BRAIDWOOD STATION

Proposed Changes to Appendix A
Technical Specifications of facility
Operating Licenses NPF-72 and NPF-77

BYRON STATION

Proposed Changes to Appendix A
Technical Specifications of facility
Operating Licenses NPF-37 and NPF-66

FIGURE 3.1-1

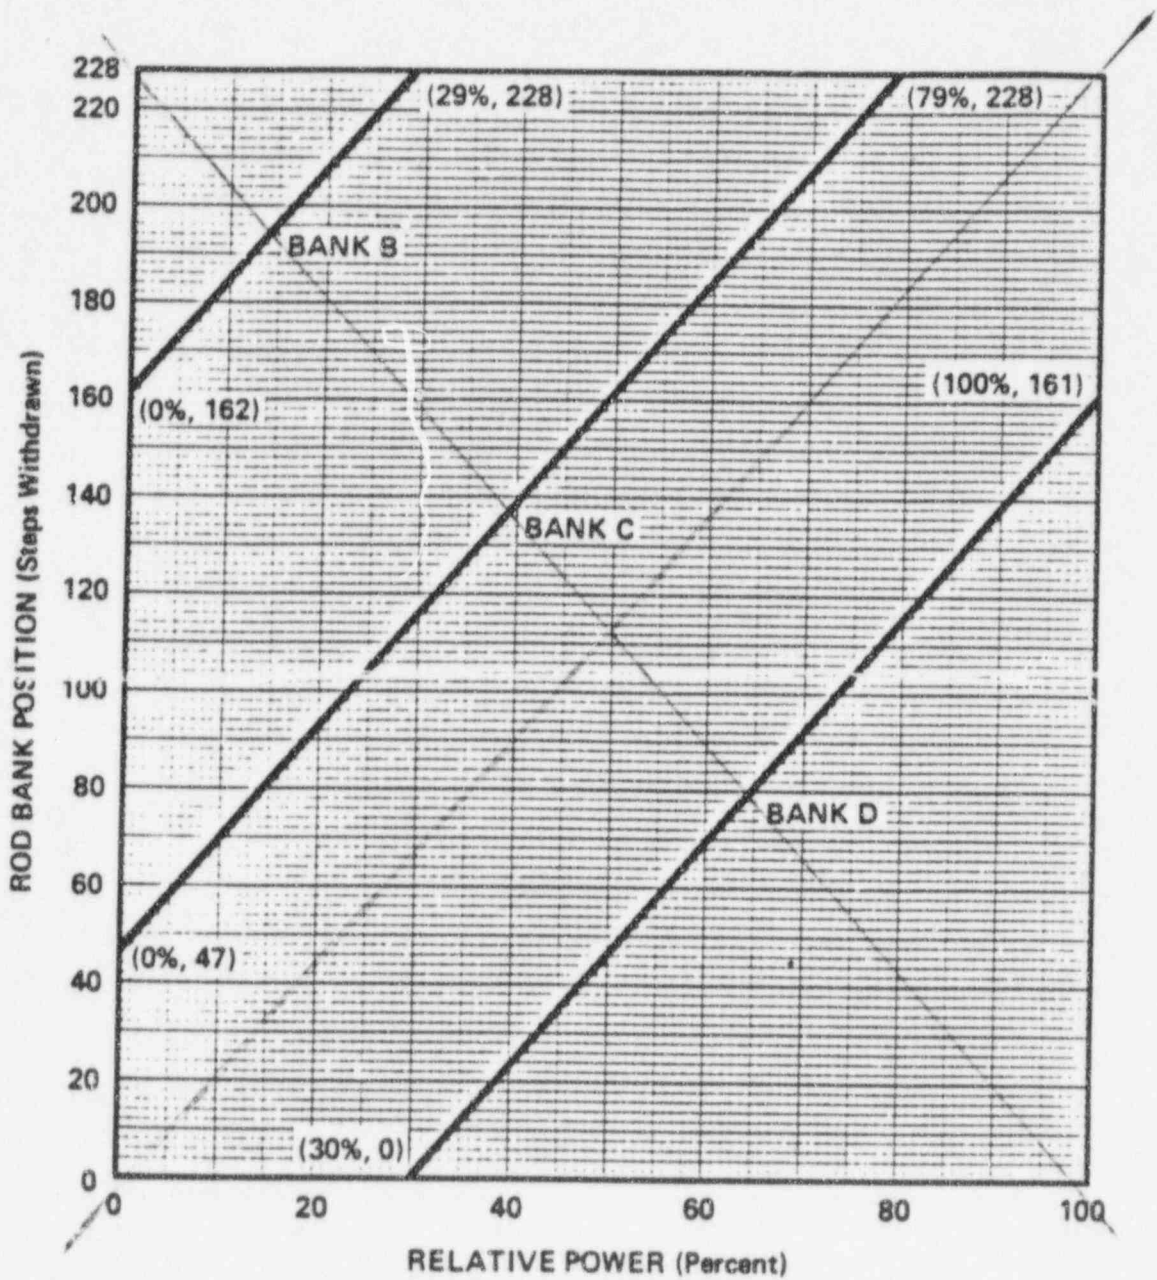
3.1.3.6 The control banks shall be limited in physical insertion as shown in Figure 3.1-1. specified in the OPERATING LIMITS REPORT.

FIGURE 3.1-1
 (THIS FIGURE IS NOT USED)

FIGURE 3.2-1
 (THIS FIGURE IS NOT USED)
~~AXIAL FLUX DIFFERENCE LIMITS AS A~~
~~FUNCTION OF RATED THERMAL POWER~~

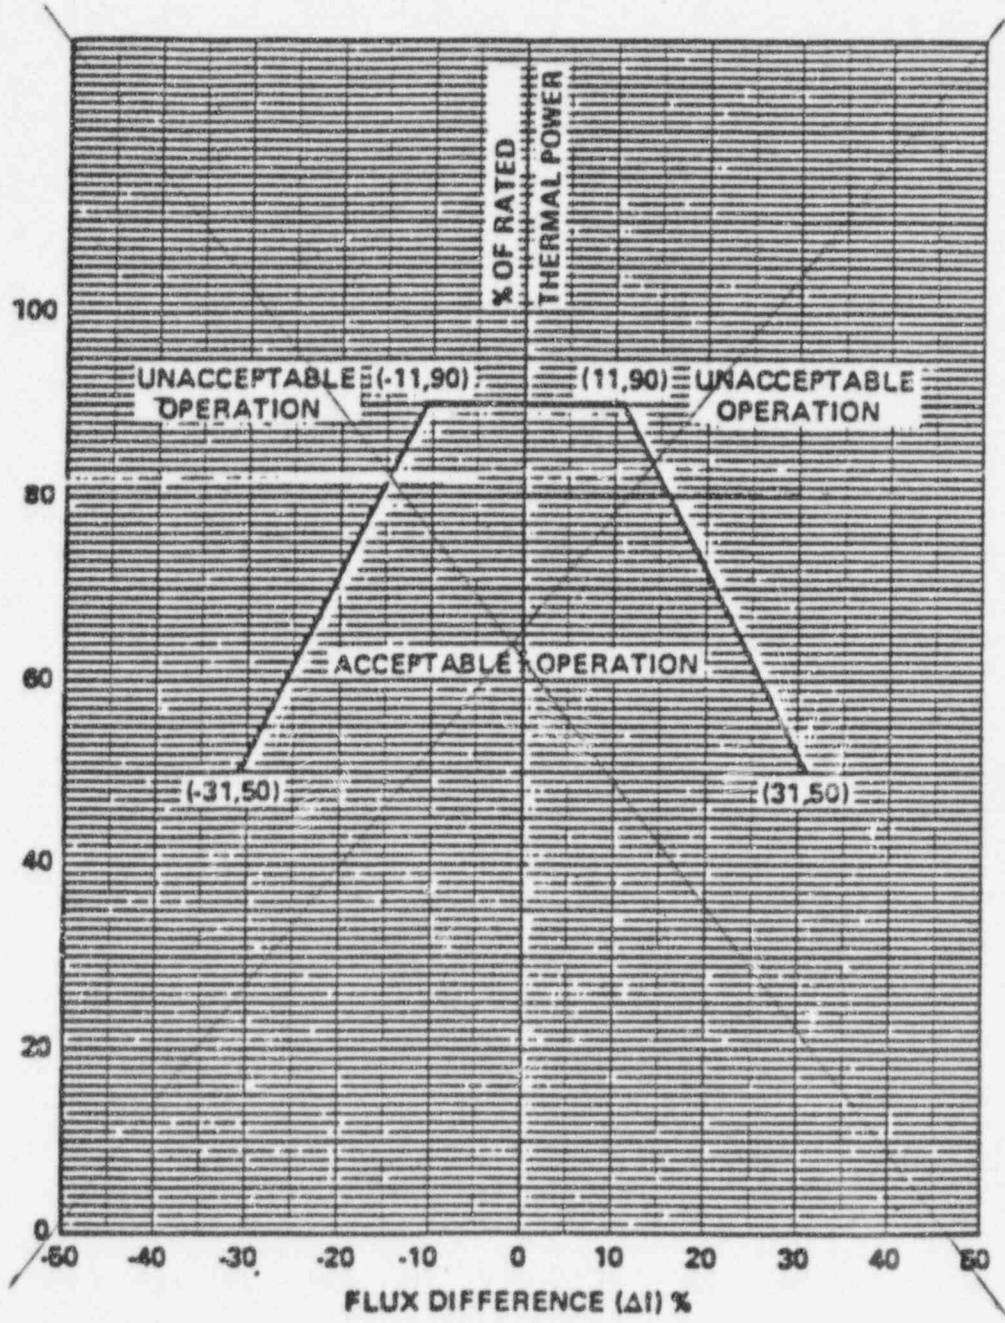
The indicated AFD may deviate outside the above required target band at greater than or equal to 50% but less than 90% of RATED THERMAL POWER provided the indicated AFD is within the Acceptable Operation Limits of Figure 3.2-1 and the cumulative penalty deviation time does not exceed 1 hour during the previous 24 hours.

Specified in the OPERATING LIMITS REPORT.

FIGURE 3.2-2
 $K(Z)$ - NORMALIZED $F_0(Z)$ AS A FUNCTION
 OF CORE HEIGHT

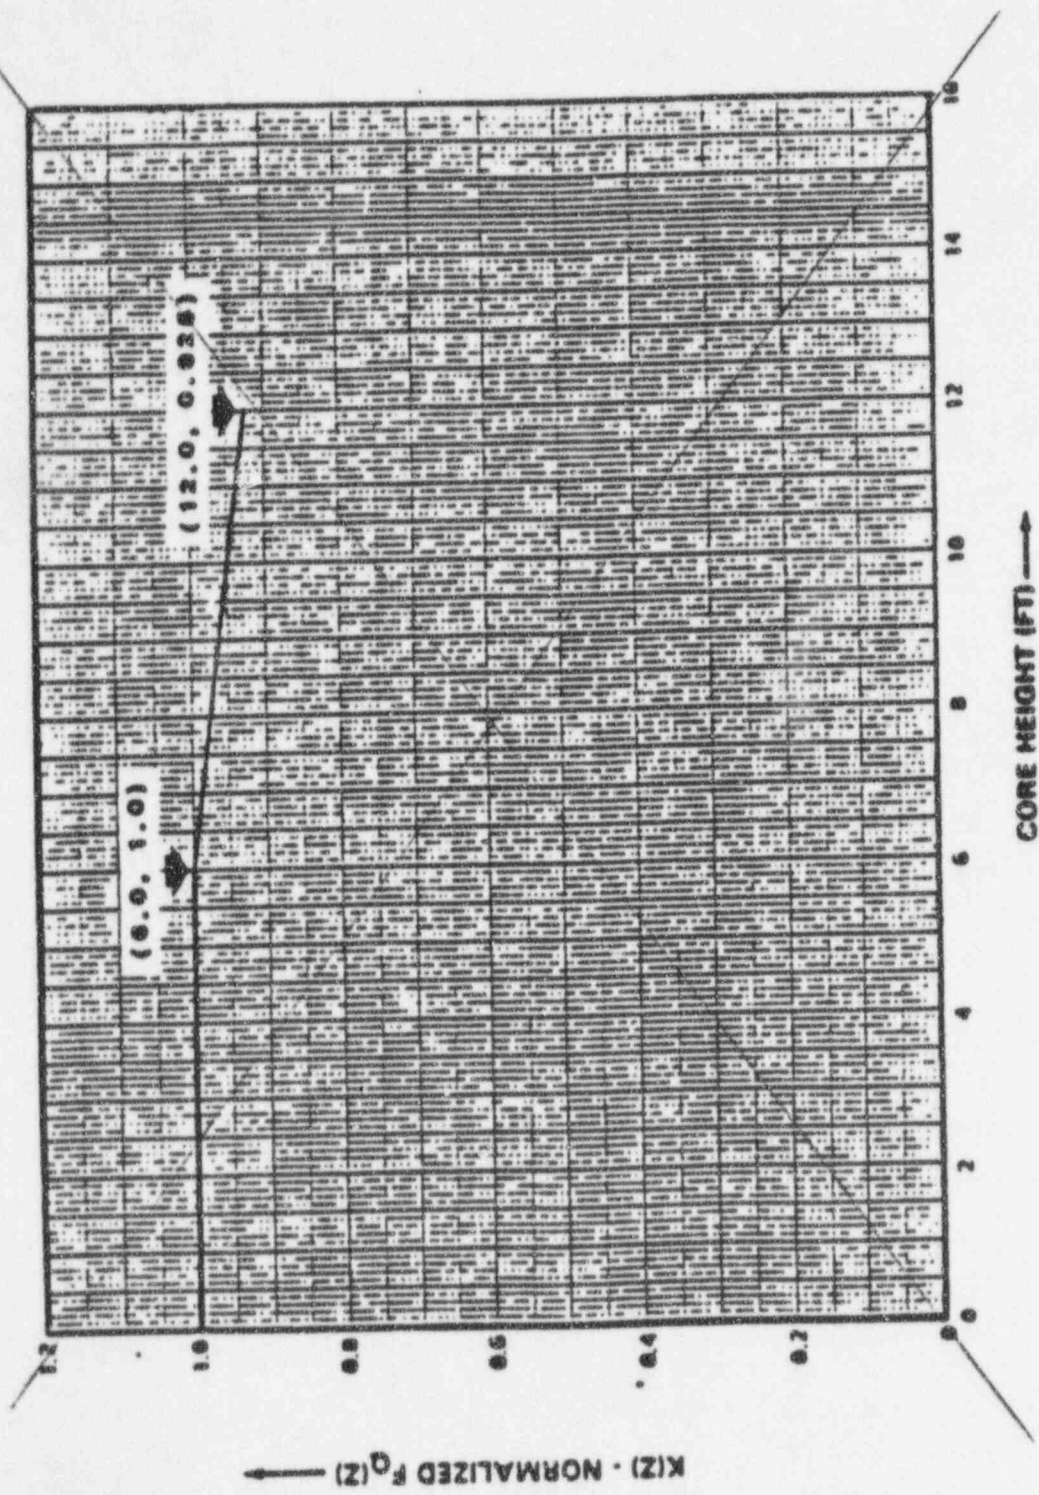
and $K(Z)$ is the function obtained from Figure 3.2-2 for a given core height location.

FIGURE 3.2-2
 (THIS FIGURE IS NOT USED)

FIGURE 3.1-1

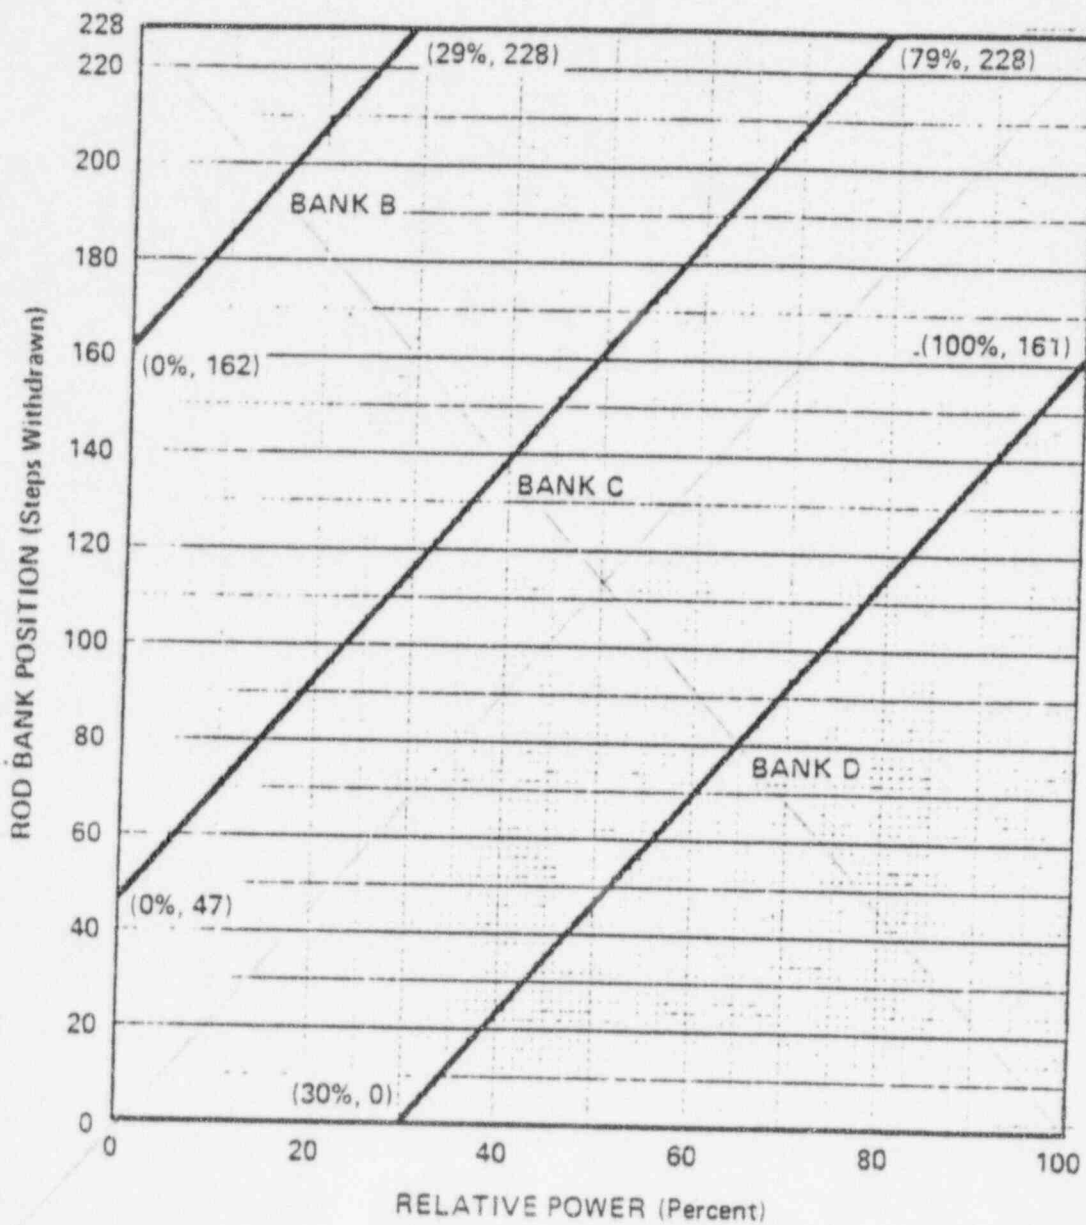
3.1.3.6 The control banks shall be limited in physical insertion as shown in Figure 3.1-1:

(THIS FIGURE IS NOT USED)

FIGURE 3.2-1

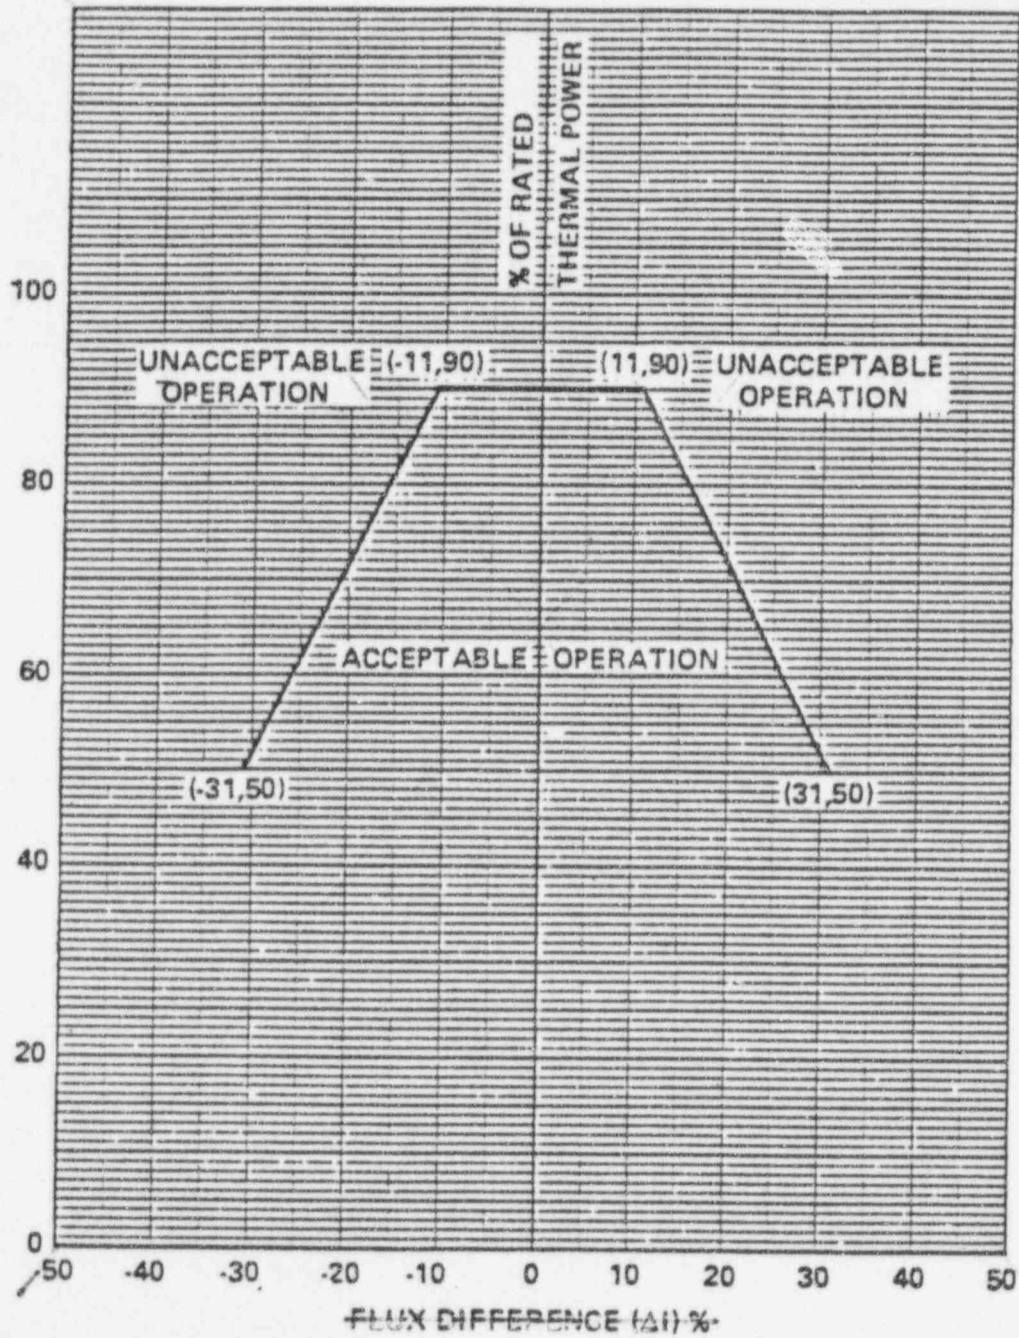
The indicated AFD may deviate outside the above required target band at greater than or equal to 50% but less than 90% of RATED THERMAL POWER provided the indicated AFD is within the Acceptable Operation Limits of Figure 3.2-1 and the cumulative penalty deviation time does not exceed 1 hour during the previous 24 hours.

(THIS FIGURE IS NOT USED)

FIGURE 3.2-2
K(z) - NORMALIZED F_Q(z) AS A FUNCTION
OF CORE HEIGHT

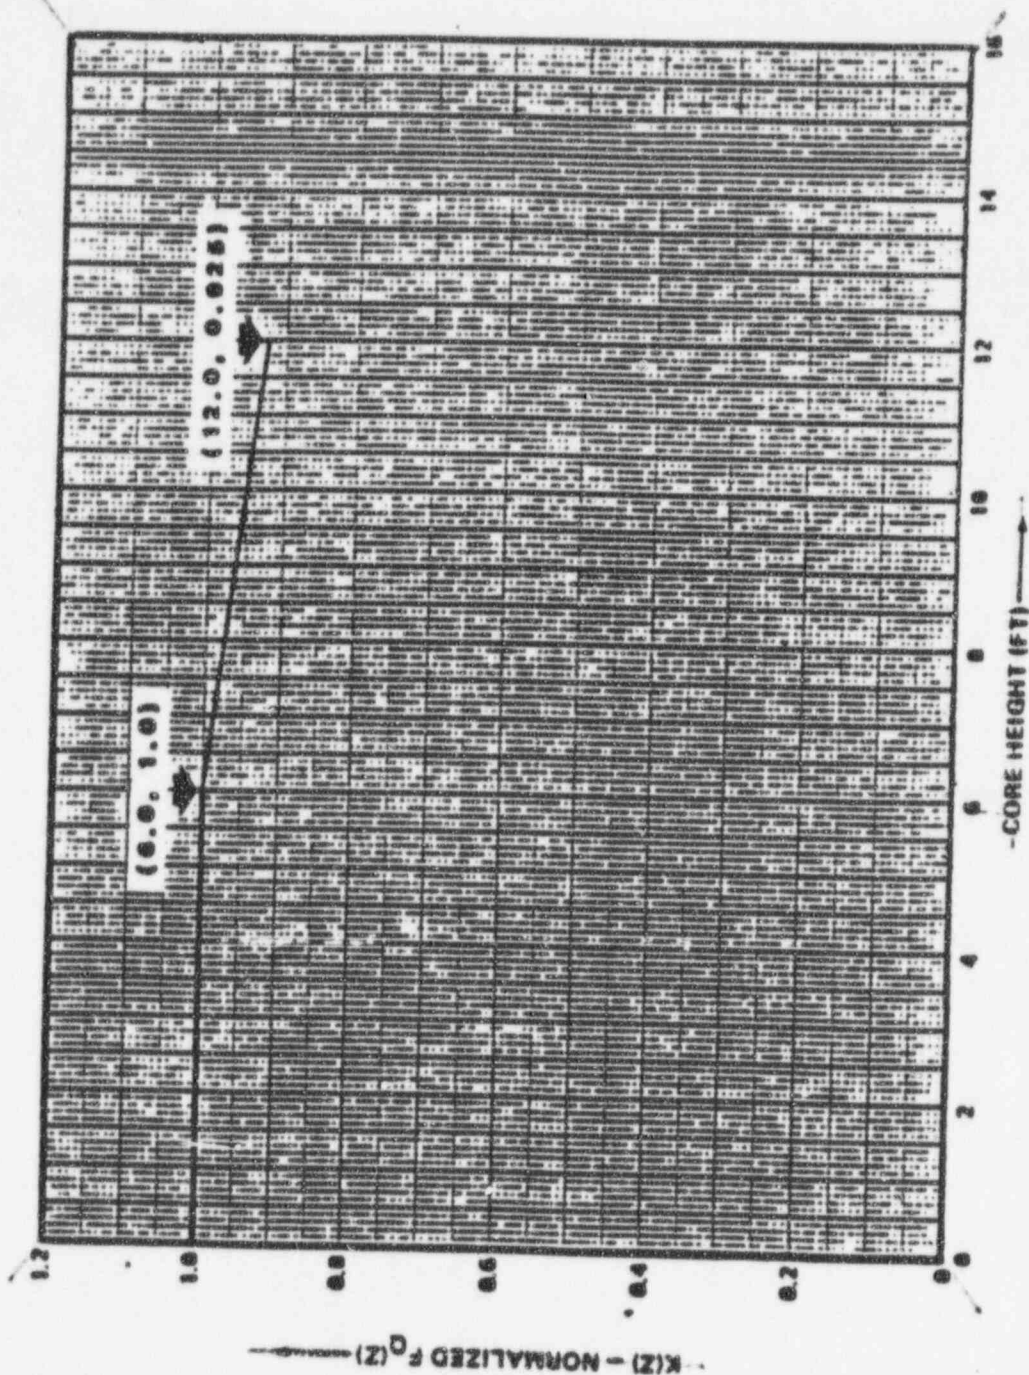
and $K(Z)$ is the function obtained from Figure 3.2-2 for a given core height location.

(THIS FIGURE IS NOT USED)
